**Notice of Intention  
To Commence Large Mining Operations**

**US Oil Sands (Utah) Inc.  
PR Spring Mine  
M0470090**

May 2009

**Figure 4c**  
**Earth Energy Resources Inc. - PR Spring Oil Sand Mine**  
**Longitudinal Mine Section N1-S1\* Rev.3**

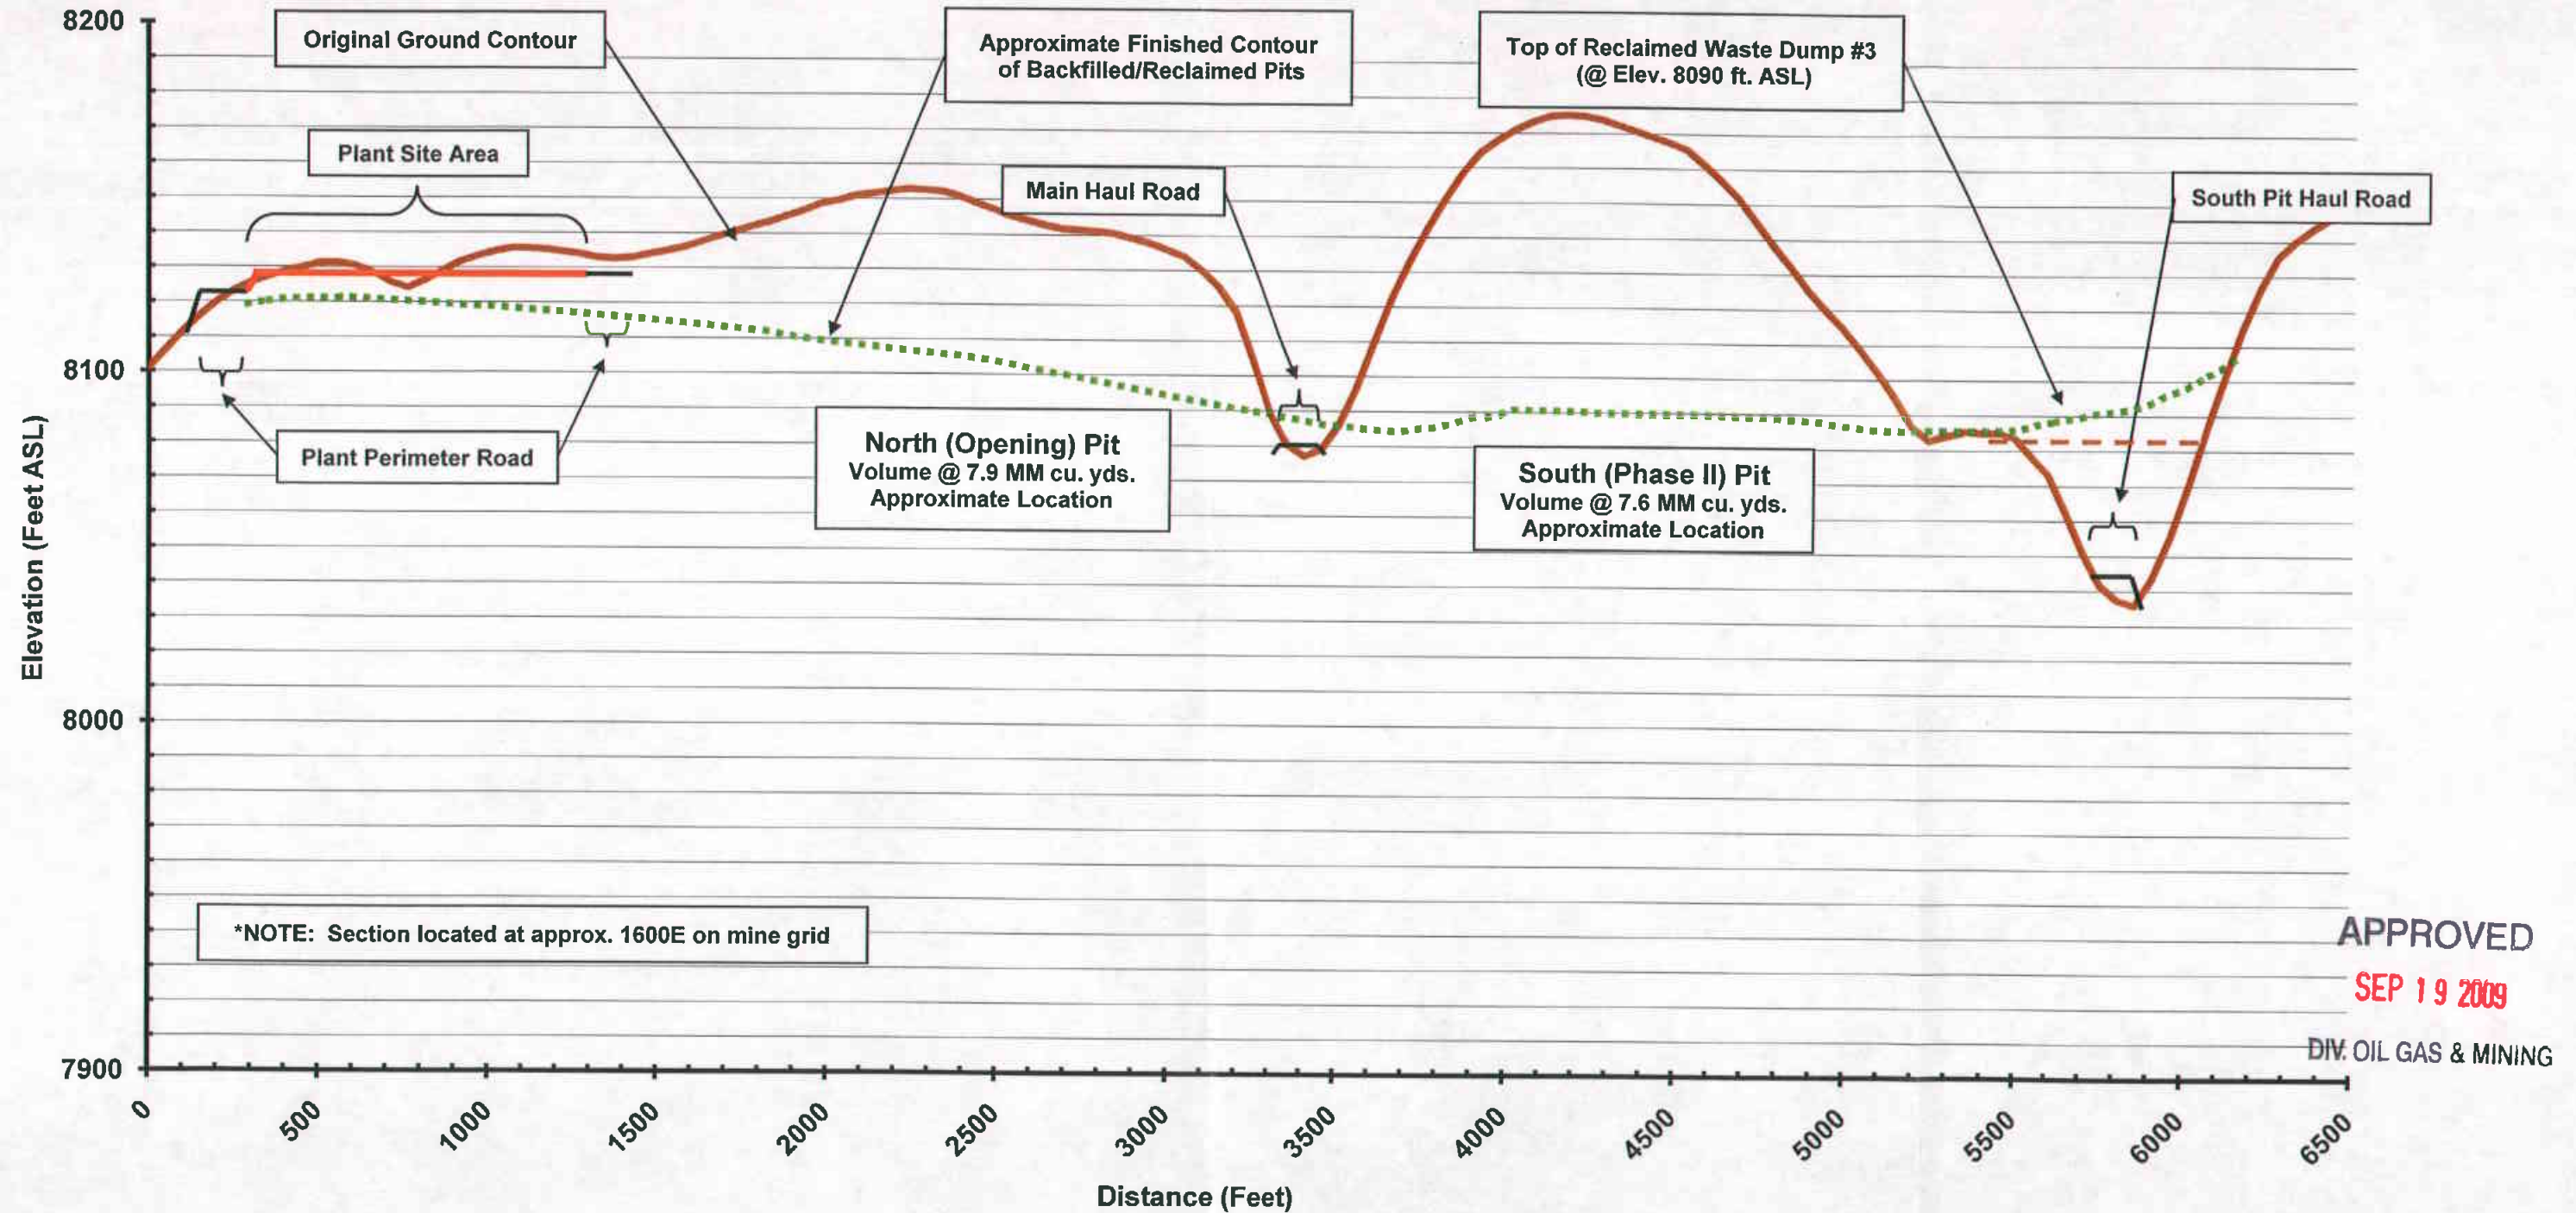
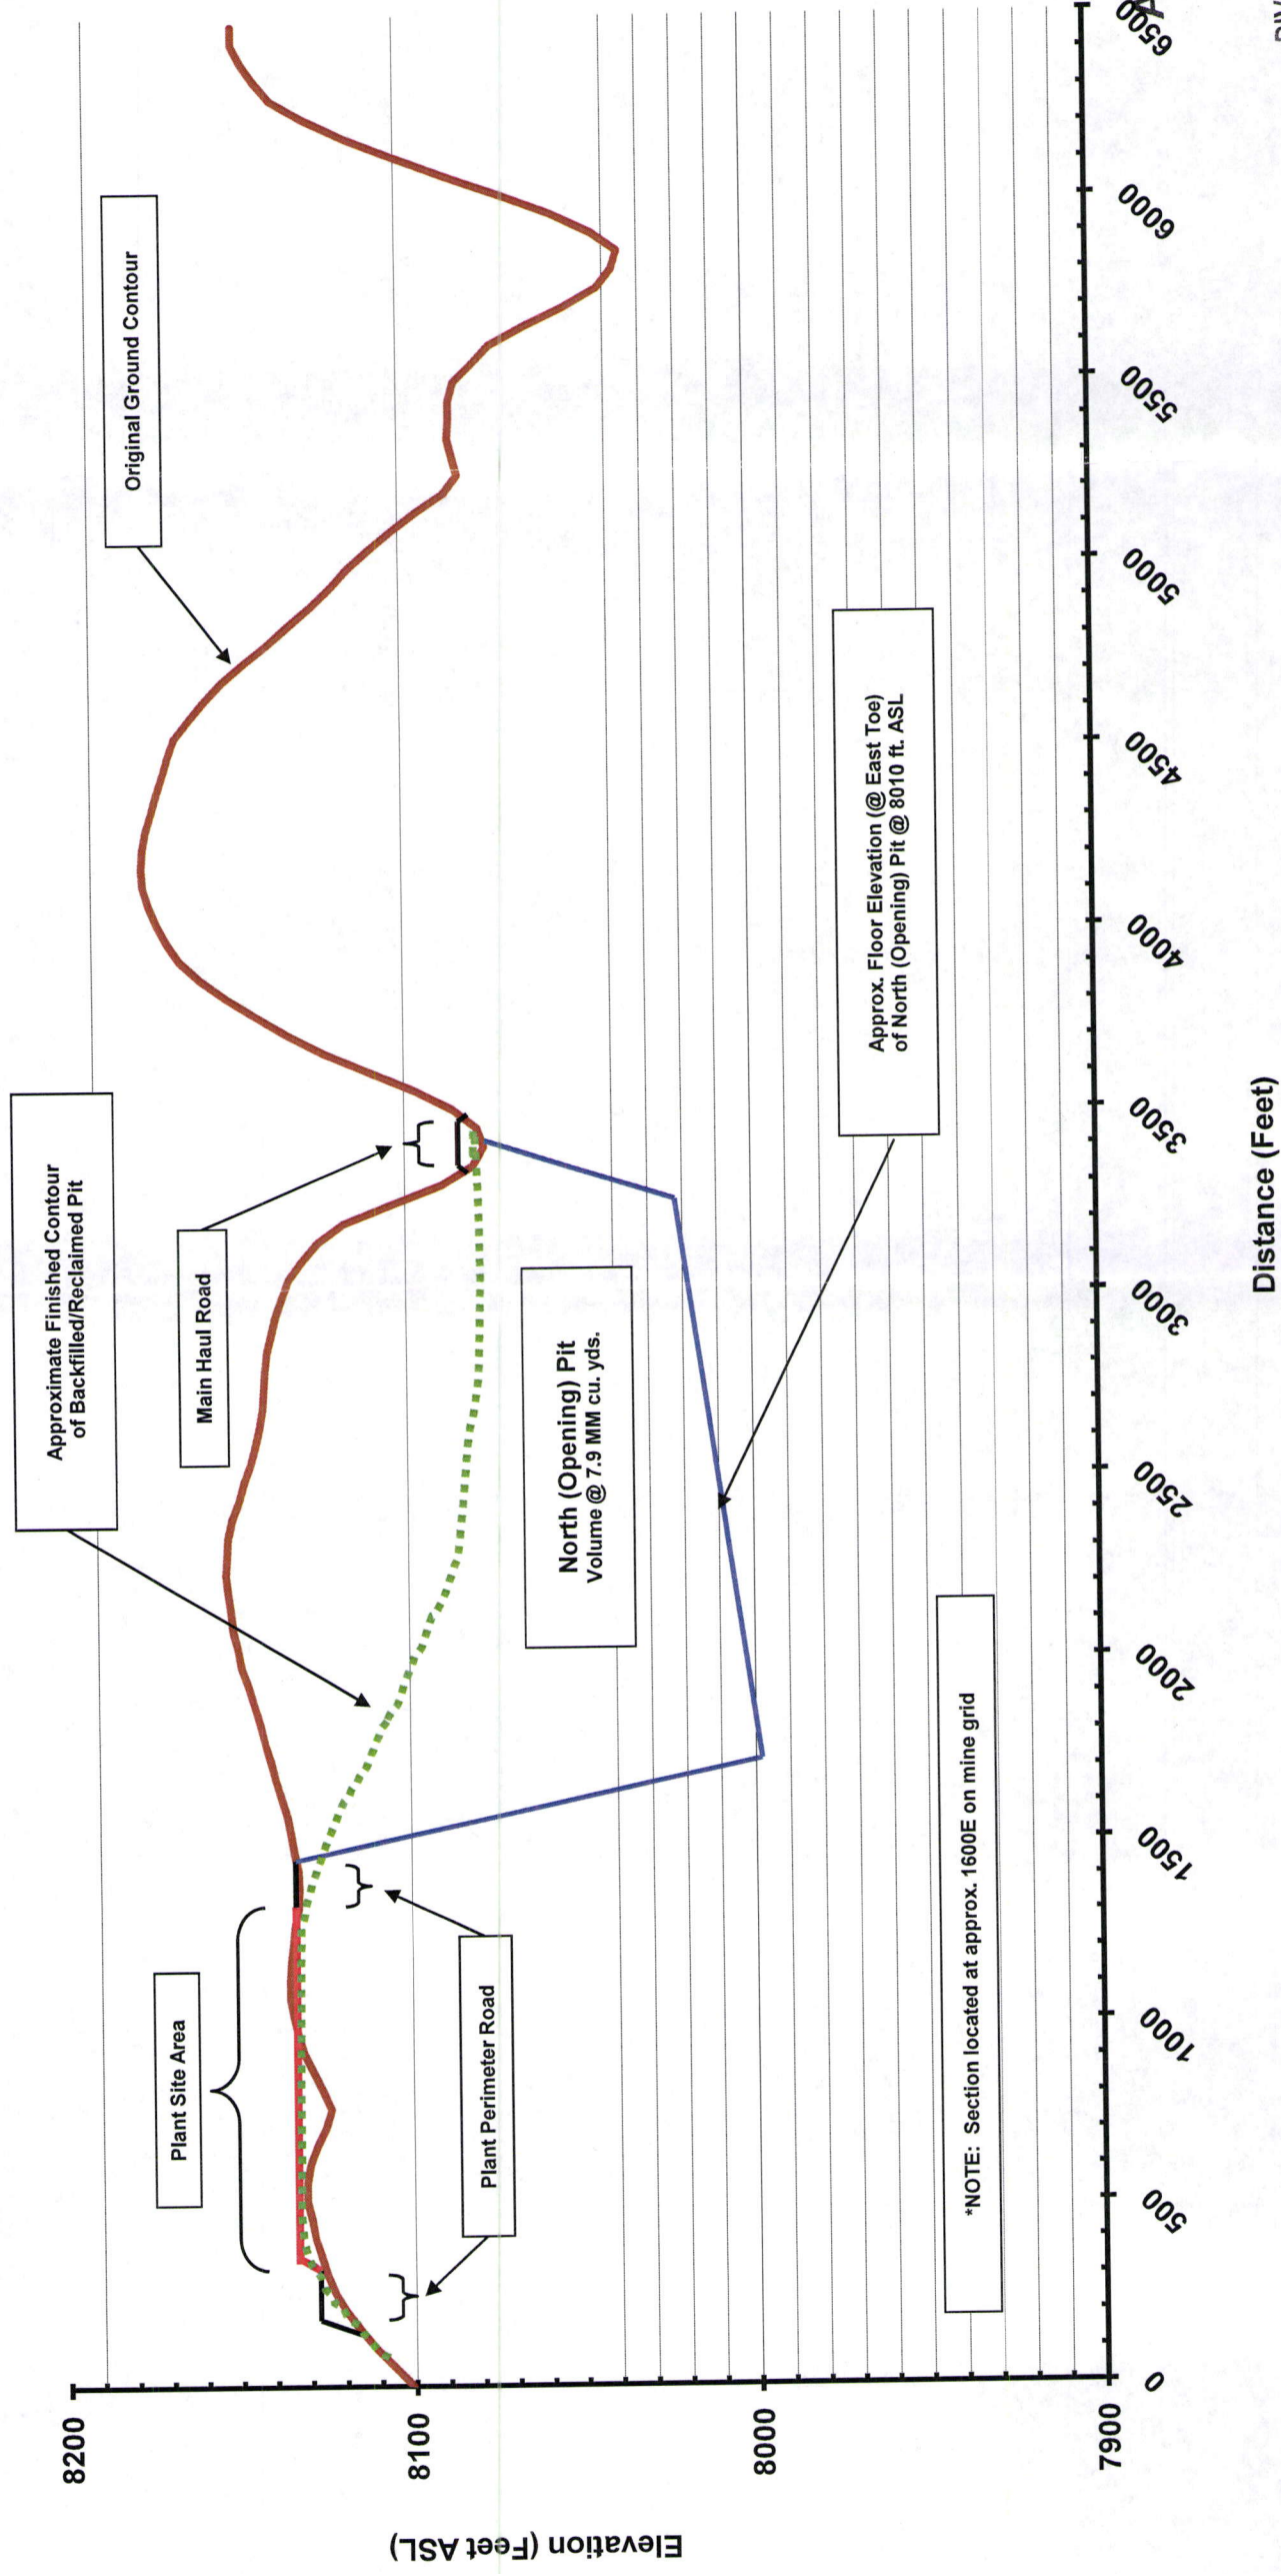
14	Figure 4a,4b,4c,6	FYI only, best if drawn with no vertical exaggeration, best if all x-sections are the same scale, engineering standards for drawing are lacking (lah)	A	Earth Energy respectfully disagrees that these cross sections are best shown without vertical exaggeration. Necessary detail would be lost if scales were equivalent, and vertical exaggeration is a standard practice to solve this problem. No changes to the scale of these drawings have been made.
15	Figure 4a,4b,4c	Slope angles shown on x-section are incorrect. (lah)	A	Earth Energy believes that the shown slope angles on all three of these figures are correct. Please note that a replacement for Figure 4b was submitted to the Division on May 15, 2008 to correct an error in the May 2008 2 <sup>nd</sup> draft NOI submittal.
16	Figure 5	As per 105.3.16 A geology map is required, include Geomechanical data; include orientation of bedding and structural features include faults, and joint sets orientations to demonstrate pit wall stability . (lah)	B	In response to a comment in the Division's Initial Review, the best available geologic map was provided as Figure 5 in the May 9, 2008 2 <sup>nd</sup> draft NOI. The response letter accompanying that 2 <sup>nd</sup> draft stated that it was the best available map. As requested by Comment # 40, generalized strike/dip information for bedding has been added to Figure 5. The other more detailed geologic information that the Division is requesting is simply not available, to Earth Energy's best knowledge, so it cannot be added to the map.

15	Figure 4a,4b,4c	Slope angles shown on xsection are incorrect. (lah)	
16	Figure 5	As per 105.3.16 A geology map is required, include Geomechanical data; include orientation of bedding and structural features include faults, and joint sets orientations to demonstrate pit wall stability . (lah)	
17	Figure 5-d	There may be related issues within the other figures and more information may be required. (BE)	
18	Figure 5-d	Is this figure to remain in the plan? Why is it labeled proprietary & confidential? (lah)	
19	Figure 9	Good regrading plan. Better scale and more detail needed (match to surety bond) needed (lah)	
20	General	As per 105.3.16 A geology map is required, include Geomechanical data; include orientation of bedding and structural features include faults, and joint sets orientations to demonstrate pit wall stability. (lah)	
21	General	A map should be submitted that shows adjacent land owners, including access road from the nearest public state road. (BE) As per 105.3.18 County road is not labeled on Figure 1 as written in text page 10 para 5 (lah)

**FIGURE 5**  
**GEOLOGY MAP**

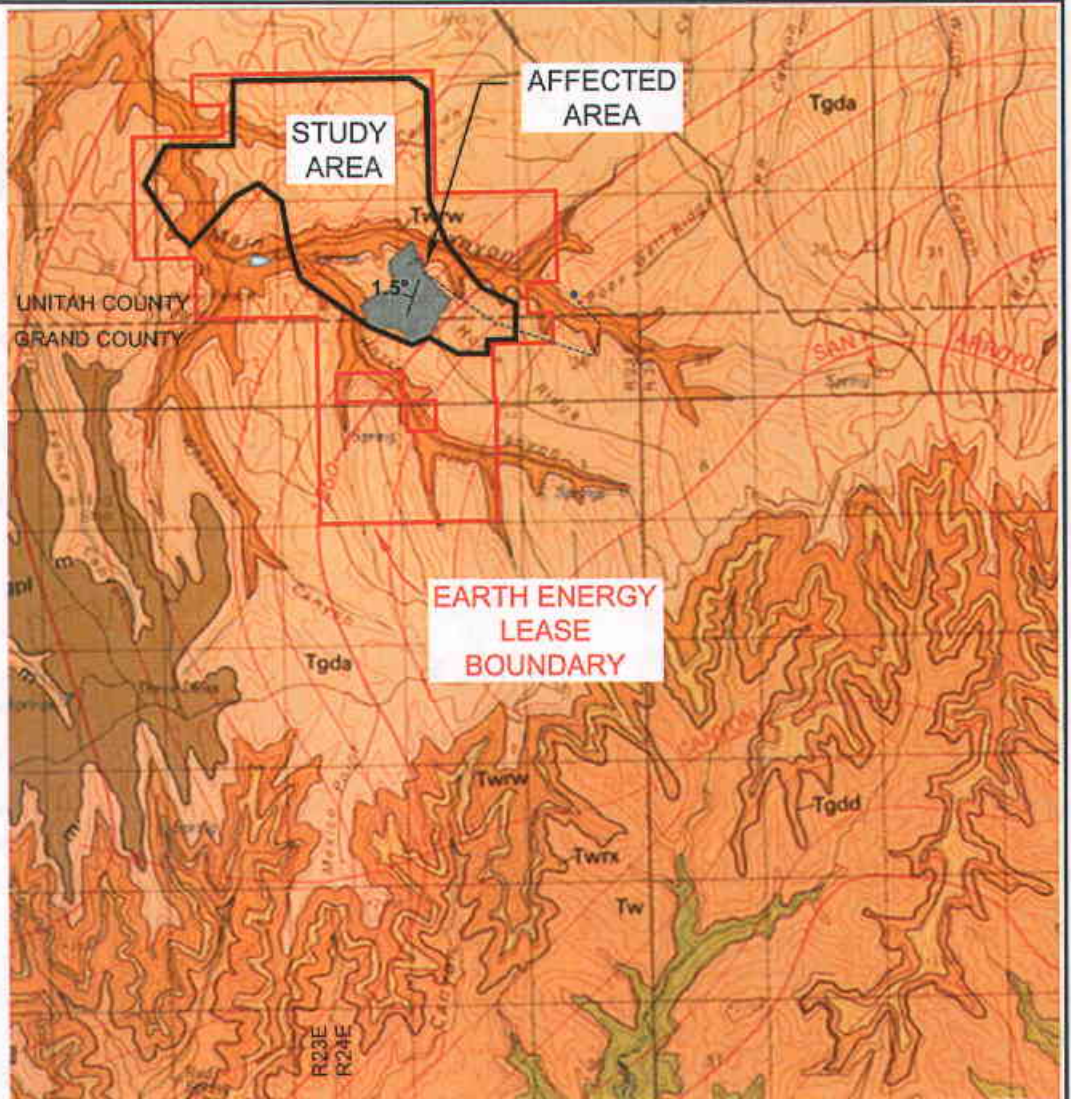
Comment #	Sheet/Page #	Comments	Review Action
38	Page 28 omission	No geologic setting is provided for ephemeral spring noted on page 29 para 4 (lah)	
39	Page 28 Para 2	"Geologic Setting" is NOT the correct title for the paragraph (lah)	
40	Page 28 para 3	Add strike and dip, and fault to Figure 5 (lah)

A geology map is now provided as Figure 5. There is no more detailed geologic mapping available.

FIGURE 1  
PROJECT LOCATION MAP

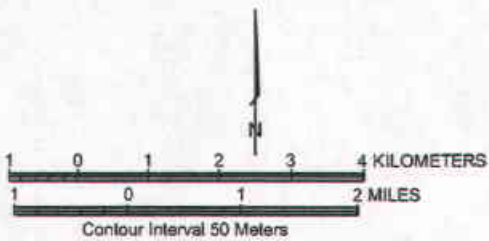
21	General	A map should be submitted that shows adjacent land owners, including access road from the nearest public state road. (BE) As per 105.3.18 County road is not labeled on Figure 1 as written in text page 10 para 5 (lah)	A	Land ownership and access road information was previously provided on Figure 2 of the May 9, 2008 2 <sup>nd</sup> draft NOI; please refer to that figure. Also, please see response to Comment #4.

The public access route to the PR Spring operation from the nearest highway is shown and labeled on an inset that has been added to Figure 1 in the April 2008 version of the NOI.
